Climate Control Blower Motor Nonfunctional

Topic number	LI83.10-N-070782
Version	1
Function group	83.10 Ventilation
Date	01-21-2020
Validity	Sprinter model 907
Reason for change	Note added to AO texts
Reason for block

Attachments	
File	Description
PTC.jpg	Example fuse arrangement layout

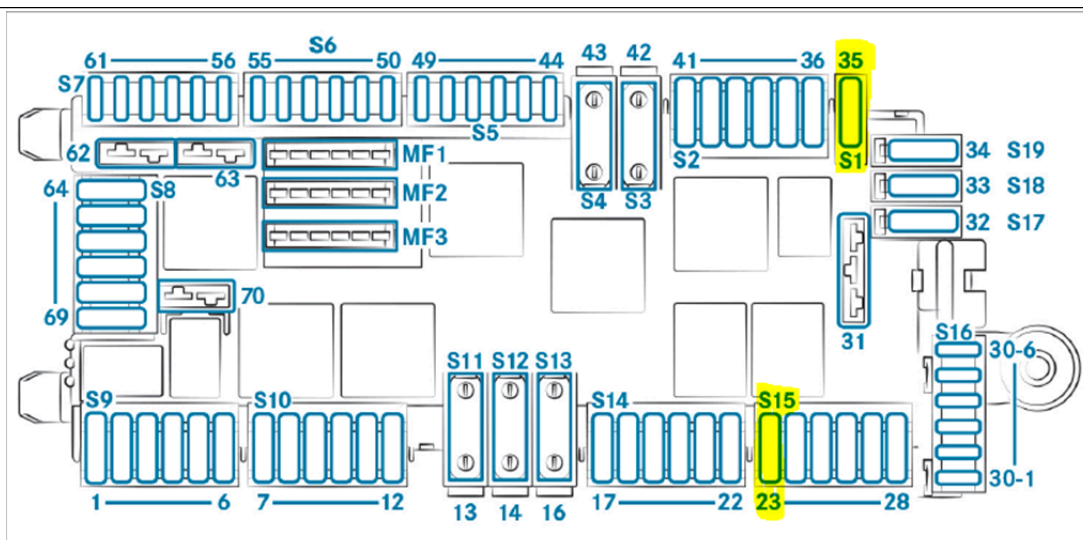
When the blower has been operated for an extended period on a high setting, the fuse may burn out.

- Relocate fuse in passenger side footwell fuse box from S15 slot 23 - 25A to S1 slot 35 - 30A (see picture in attachment).
- Disconnect cable at slot 23, partially open the wiring harness, connect fuse holder A 006 545 06 01 to slot 35, attach the cable to it and install a 30A fuse.
- Re-close the wiring harness.

- Cross out 25A blower regulator fuse at position S15 -slot 23
- Overwrite position S1 - slot 35 with blower regulator and 30A.
